IEEE802.3dj Modal ERL Proposal

Addressing d2.3 comments 40, 41, 42

Richard Mellitz, Samtec

March 2026, Vancouver, BC, Canada IEEE P802.3dj Plenary

Modal Pulse Time-Domain Reflections

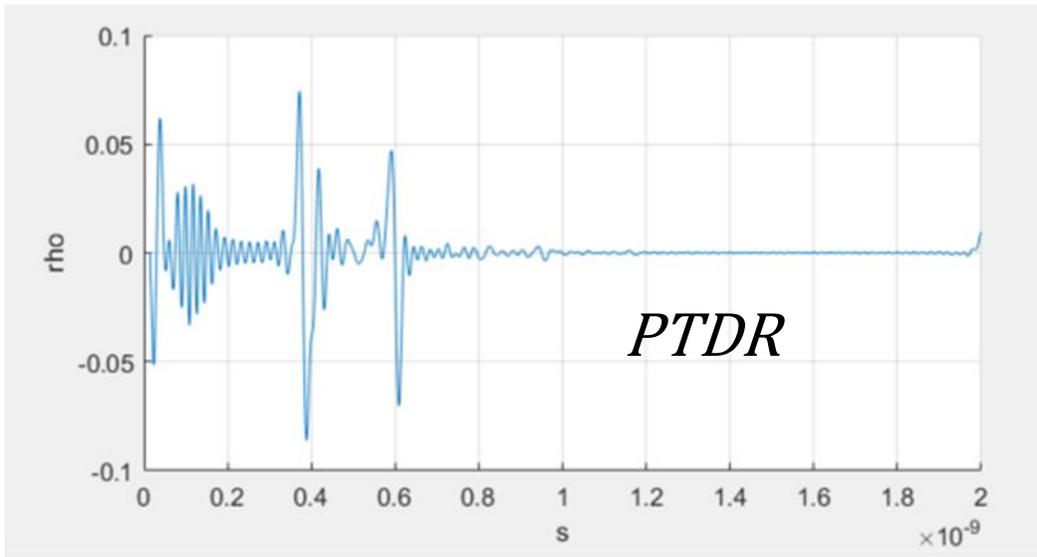
- ❑ Using the filtered return loss functions compute modal *PTDR* using ERL *PTDR* as the basis
- ❑ Reference modal S-parameter naming as defined in 178A.1.2

The filtered modal return losses functions $H_{ccii}(f)$, $H_{cdii}(f)$, and $H_{dcii}(f)$, are defined by Equations (178A–61)

The modal pulse TDR signals $PTDR_{cc}(t)$, $PTDR_{cd}(t)$, and $PTDR_{dc}(t)$ are defined by Equation (178A–62).

$$PTDR_{cc}(t) = \int_{-\infty}^{\infty} X(f) H_{ccii}(f) \exp(j2\pi ft) df \quad (178A-62a)$$

$$PTDR_{cd}(t) = \int_{-\infty}^{\infty} X(f) H_{cdii}(f) \exp(j2\pi ft) df \quad (178A-62b)$$

$$PTDR_{dc}(t) = \int_{-\infty}^{\infty} X(f) H_{dcii}(f) \exp(j2\pi ft) df \quad (178A-62c)$$

Effective modal reflection waveforms

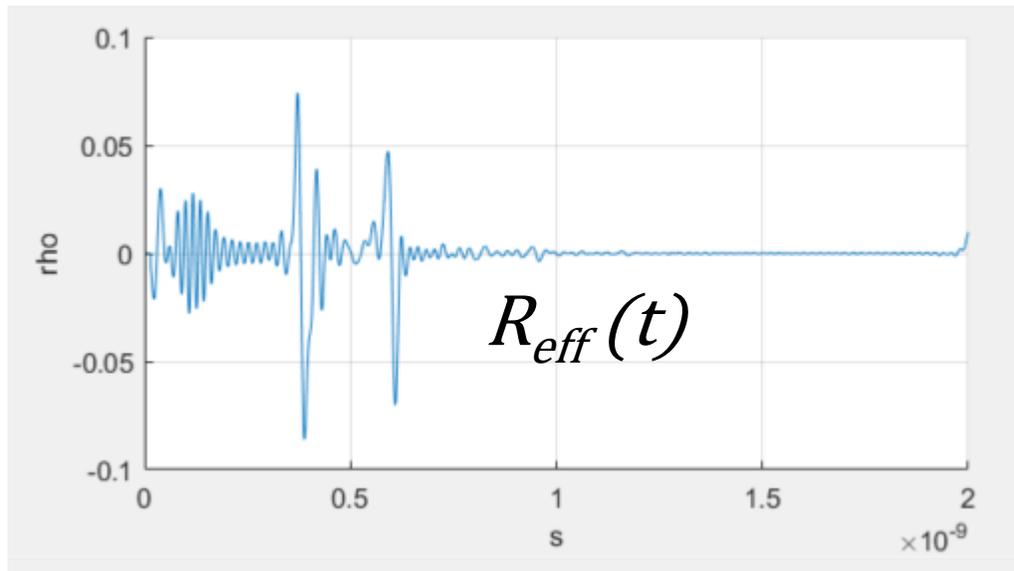
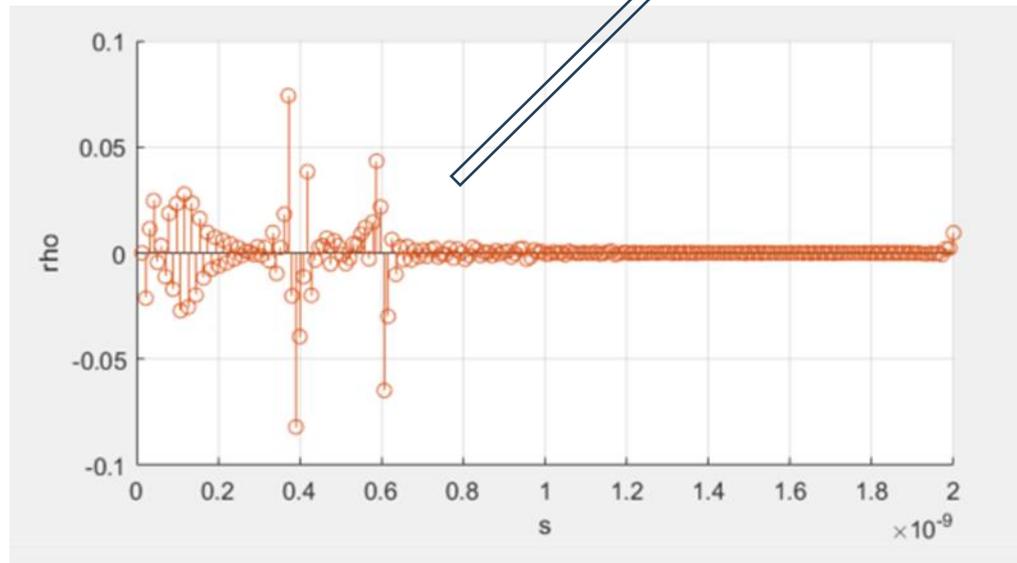
- Compute effective modal reflection waveforms, $R_{eff}(t)$, from modal *PTDR* using 93A gating functions (G_{rr} and G_{loss})

The effective modal reflection waveforms $R_{cceff}(t)$, $R_{cdeff}(t)$, and $R_{dceff}(t)$ are computed by time gating and weighting the PTDR waveforms $PTDR_{cc}(t)$, $PTDR_{cd}(t)$, and $PTDR_{dc}(t)$ per Equation (178A-63). $R_{cceff}(t)$, $R_{cdeff}(t)$, and $R_{dceff}(t)$ are pure numbers.

$$R_{cceff}(t) = PTDR_{cc}(t) \times G_{rr}(t) \times G_{loss}(t) \quad (178A-63a)$$

$$R_{cdeff}(t) = PTDR_{cd}(t) \times G_{rr}(t) \times G_{loss}(t) \quad (178A-63b)$$

$$R_{dceff}(t) = PTDR_{dc}(t) \times G_{rr}(t) \times G_{loss}(t) \quad (178A-63c)$$

Sample Variances

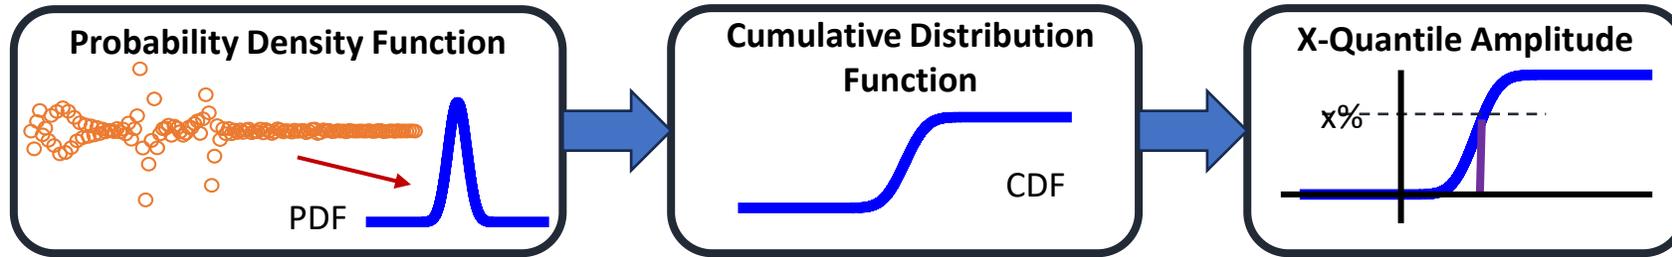
- ❑ Compute reflection variance for each reflection sample offset

The standard deviation of the distributions of the modal reflection signals for each phase m for s is defined by Equation (178A-65).

$$\sigma_{cch}^{(m)} = \sqrt{\sum_{n=1}^N \left(h_{cc}^{(m)}(n) \right)^2} \quad (178A-65a)$$

$$\sigma_{cdh}^{(m)} = \sqrt{\sum_{n=1}^N \left(h_{cd}^{(m)}(n) \right)^2} \quad (178A-65b)$$

$$\sigma_{dch}^{(m)} = \sqrt{\sum_{n=1}^N \left(h_{dc}^{(m)}(n) \right)^2} \quad (178A-65c)$$
